UNITED STATES PATENT AND TRADEMARK OFFICE

APPLICATION NO.	FILING DATE	FIRST NAMED INVENTOR	ATTORNEY DOCKET NO.	CONFIRMATION NO.
10/057,229	01/25/2002	Durward S. Benham JR.	170-99-X44	3036

Office Action Summary

DETAILED ACTION

FIG. 4

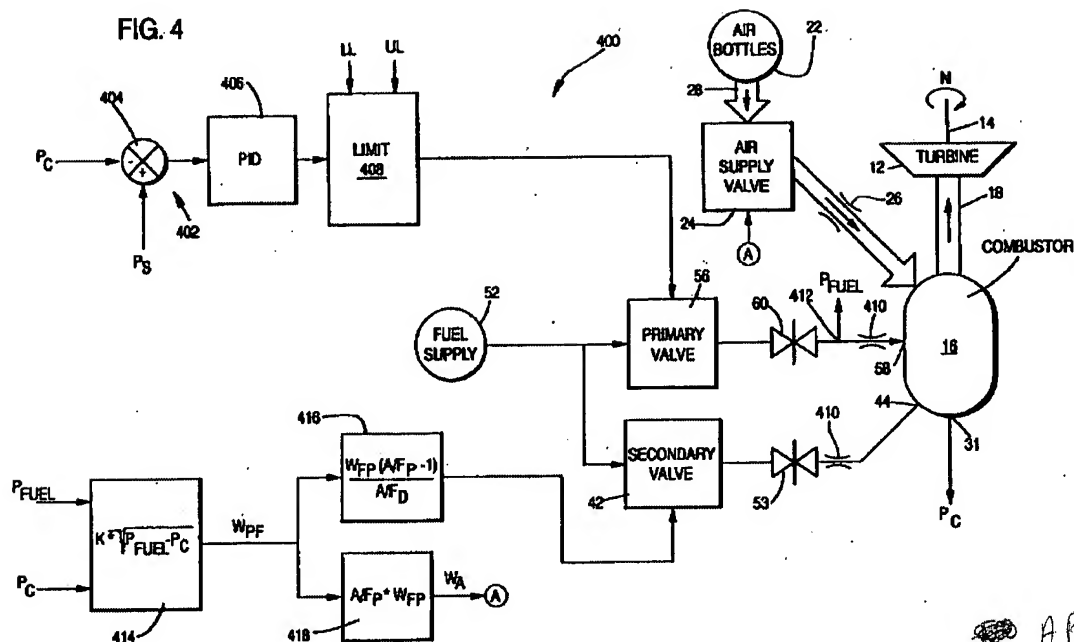
4. Claims 1, 2, 6, 7, 9, 15, 16, (17), (19) and (20) are rejected under 35 U.S.C. 102(b) as being anticipated by **Lampe et al.** (U.S patent No. 5,097,659).

5. With respect to claim 1, **Lampe et al.** teach an apparatus for generating auxiliary and emergency power. This apparatus comprises a source of pressurized air 22; a source of jet fuel 52; a turbine 12; an airflow passageway joining the source of pressurized air 22 to the turbine 12; a fuel flow passage joining the source of jet fuel 52 to the turbine 12; and a separate valve assembly 24, 26, 56, 42, 60, 53, 410 located in each flow passageway for controlling the flow of compressed air and jet fuel into the turbine. See particularly **Figure 4**; column 1 lines 7-8; and column 6 lines 10-12 of Lampe.

6. With respect to claim 2, **Lampe et al.** teach that the source of compressed air 22 comprises at least one high-pressure storage vessel. See particularly **Figure 4** and column 5 lines 20-22 of Lampe.

7. With respect to claim 6, **Lampe et al.** teach that the valve assembly located in the fuel flow passageway comprises a modulating fuel control valve 56. See particularly **Figure 4** of Lampe.

8. With respect to claim 7, **Lampe et al.** teach that the valve assembly located in the fuel flow passageway comprises a fixed orifice valve 410. See particularly **Figure 4** of Lampe.

9. With respect to claim 9, **Lampe et al.** teach an apparatus for generating auxiliary and emergency power. This apparatus comprises a source of pressurized air comprising at least one storage vessel 22; a source of jet fuel comprising a fuel tank 52; a turbine 12; an airflow passageway joining the source of pressurized air 22 to the turbine 12; a fuel flow passage joining the source of jet fuel 52 to the turbine 12; and a separate valve assembly 24, 26, 56, 42, 60, 53, 410 located in each flow passageway for controlling the flow of compressed air and jet fuel into the turbine. See particularly **Figure 4**; column 1 lines 7-8; column 5 lines 20-22; and column 6 lines 10-12 of Lampe.

10. With respect to claim 15, **Lampe et al.** teach that the valve assembly located in the fuel flow passageway comprises a modulating fuel control valve 56. See particularly **Figure 4** of Lampe.

11. With respect to claim 16, **Lampe et al.** teach that the valve assembly located in the fuel flow passageway comprises a fixed orifice valve 410. See particularly **Figure 4** of Lampe.

12. With respect to claim 17, **Lampe et al.** teach an apparatus for generating auxiliary and emergency power. This apparatus comprises a source of pressurized air comprising at least one storage vessel 22; a source of jet fuel comprising a fuel tank 52; a turbine 12; an airflow passageway joining the source of pressurized air 22 to the turbine 12; a fuel flow passage joining the source of jet fuel 52 to the turbine 12; and a modulating valve assembly 24, 26 located in the air flow passageway and a control valve 56 located in the fuel flow passageway for controlling

the flow of compressed air and jet fuel into the turbine. See particularly **Figure 4**; column 1 lines 7-8; column 5 lines 20-22; and column 6 lines 10-12 of Lampe.

13. With respect to claim 19, **Lampe et al.** teach that the control valve comprises a fixed orifice valve 410 located between the fuel tank 52 and the turbine 12. See particularly **Figure 4** of Lampe.

Figure 1.

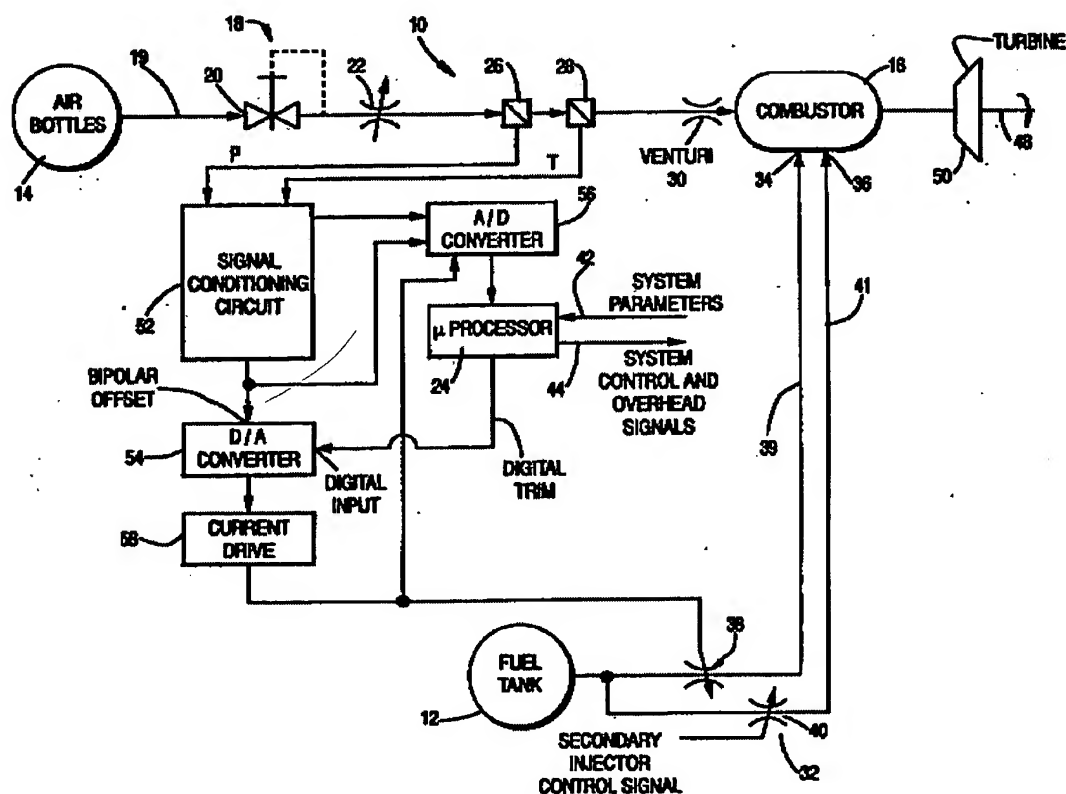
15. Claims 1, 2, 4, 5, 7, 9, 13, 14 and 16-20 are rejected under 35 U.S.C. 102(b) as being anticipated by **Lampe et al.** (U.S patent No. 5,031,398).

16. With respect to claim 1, **Lampe et al.** teach an apparatus for generating auxiliary and emergency power. This apparatus comprises a source of pressurized air 14; a source of jet fuel 12; a turbine 50; an airflow passageway joining the source of pressurized air 14 to the turbine 50; a fuel flow passage joining the source of jet fuel 12 to the turbine 50; and a separate valve assembly 20, 22, 38, 40 located in each flow passageway for controlling the flow of compressed air and jet fuel into the turbine. See particularly **Figure 1**; column 1 lines 66 to column 2 lines 1-2 of Lampe.

17. With respect to claim 2, **Lampe et al.** teach that the source of compressed air 14 comprises at least one high-pressure storage vessel. See particularly **Figure 1** and column 4 lines 1-3 of Lampe.

18. With respect to claim 4, **Lampe et al.** teach that the valve assembly located in the air flow passageway comprises a modulating air control valve 22 and a separate regulator and shutoff valve 20 located between the air control valve 22 and the source of pressurized air 14. See particularly **Figure 1** of Lampe.

19. With respect to claim 5, **Lampe et al.** teach that the valve assembly located in the air flow passageway comprises a fixed orifice valve 30 and a separate regulator and shutoff valve 20 located between the fixed orifice valve 30 and the source of pressurized air 14. See particularly **Figure 1** of Lampe.

20. With respect to claim 7, **Lampe et al.** teach that the valve assembly located in the fuel flow passageway comprises a fixed orifice valve 38. See particularly **Figure 1** of Lampe.

storage vessel 14; a source of jet fuel comprising a fuel tank 12; a turbine 50; an airflow passageway joining the source of pressurized air 14 to the turbine 50; a fuel flow passage joining the source of jet fuel 12 to the turbine 50; and a separate valve assembly 20, 22, 38, 40 located in each flow passageway for controlling the flow of compressed air and jet fuel into the turbine. See particularly **Figure 1**; column 1 lines 66 to column 2 lines 1-2 of Lampe.

22. With respect to claim 13, **Lampe et al.** teach that the valve assembly located in the air flow passageway comprises a modulating air control valve 22 and a separate regulator and shutoff valve 20 located between the air control valve 22 and the source of pressurized air 14. See particularly **Figure 1** of Lampe.

23. With respect to claim 14 **Lampe et al.** teach that the valve assembly located in the air flow passageway comprises a fixed orifice valve 30 and a separate regulator and shutoff valve 20 located between the fixed orifice valve 30 and the source of pressurized air 14. See particularly **Figure 1** of Lampe.

24. With respect to claim 16, **Lampe et al.** teach that the valve assembly located in the fuel flow passageway comprises a fixed orifice valve 38. See particularly **Figure 1** of Lampe.

25. With respect to claim 17, **Lampe et al.** teach an apparatus for generating auxiliary and emergency power. This apparatus comprises a source of pressurized air comprising at least one storage vessel 14; a source of jet fuel comprising a fuel tank 12; a turbine 50; an airflow passageway joining the source of pressurized air 14 to the turbine 50; a fuel flow passage joining the source of jet fuel 12 to the turbine 50; and modulating valve assembly 20, 22, 30 located in the air flow passageway and a control valve 38 located in the fuel flow passageway for

controlling the flow of compressed air and jet fuel into the turbine 50. See particularly **Figure 1**; column 1 lines 66 to column 2 lines 1-2 of Lampe.

26. With respect to claim 18, **Lampe et al.** teach that the valve assembly located in the air flow passageway comprises a modulating air control valve 22 and a separate regulator and shutoff valve 20 located between the air control valve 22 and the source of pressurized air 14. See particularly **Figure 1** of Lampe.

27. With respect to claim 19, **Lampe et al.** teach that the valve assembly located in the fuel flow passageway comprises a fixed orifice valve 38. See particularly **Figure 1** of Lampe.
